HISTORIC AND DESIGN REVIEW COMMISSION

May 06, 2015

HDRC CASE NO: 2015-170
ADDRESS: 338 MADISON ST
LEGAL DESCRIPTION: NCB 744 BLK 3 LOT 19 AND 20
ZONING: RM4 H HE
CITY COUNCIL DIST.: 1
DISTRICT: King William Historic District
LANDMARK: Berman / Kinder House
APPLICANT: Richard Bailey
OWNER: Boothe Bros Paving
TYPE OF WORK: Fencing, site work and fountain installation
REQUEST:

338 MADISON ST.

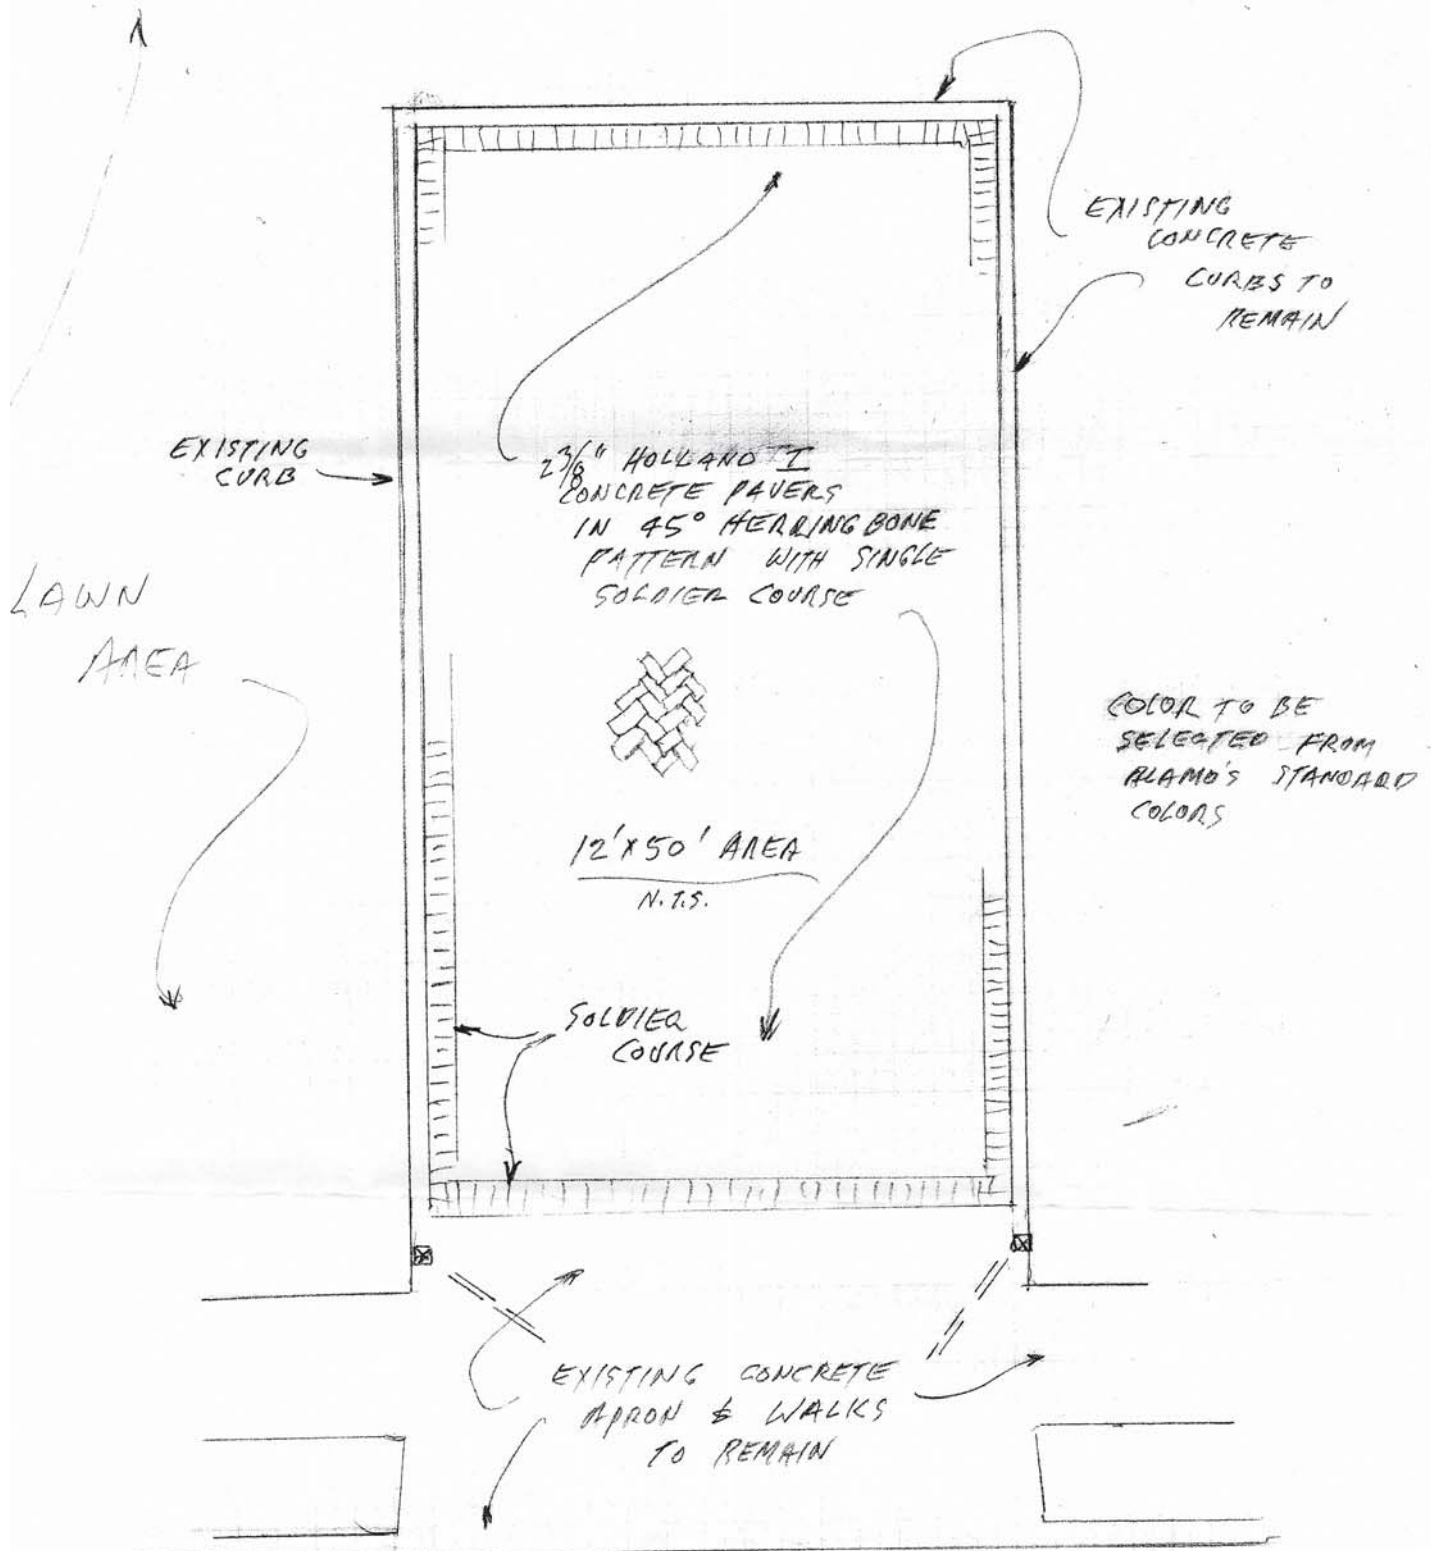
- b. The applicant has proposed to install a front yard fountain within the existing front yard garden and existing circular walkway. The proposed fountain is constructed of dark cement like materials and is to be approximately six (6) feet tall. Staff finds that the proposed fountain is similar to yard art or yard furniture and does not contain elements that would jeopardize the historic integrity of the primary structure or property.

- c. The applicant has proposed to install a wrought iron fence on the north, east and west sides of the property to match an existing wrought iron fence on the southwest side of the property. The installation of a wrought iron fence in these locations is appropriate and consistent with the Guidelines, however, staff recommends that the proposed fence not include the non historic square channel tubing that currently borders the existing wrought iron gate. According to the Guidelines, front and side yard fences are not to exceed four (4) feet in height. The applicant is responsible for complying with the Guidelines for Site Elements 2.B.iii regarding the height of the proposed fence.

- d. The applicant has proposed to install 2 3/8 inch concrete pavers in a 45 degree pattern in the existing rear driveway to replace the existing loose gravel. According to the Guidelines for Site Elements 5.B.i., materials, width and design of existing driveways or other paved features should be incorporated into the design of new or altered driveways. Staff finds that given the existing rear driveway's location, its existing screening by a site wall and the proposed paving materials that this proposal is appropriate. Staff recommends that the applicant incorporate a permeable based to accommodate water drainage.

- i. That the proposed fence not include the non historic square channel tubing that currently borders the existing wrought iron gate.
- ii. that the applicant incorporate a permeable based to accommodate water drainage beneath the proposed concrete paver system.

Staff recommends approval of items #1 through #3 based on findings a through d with the following stipulations:
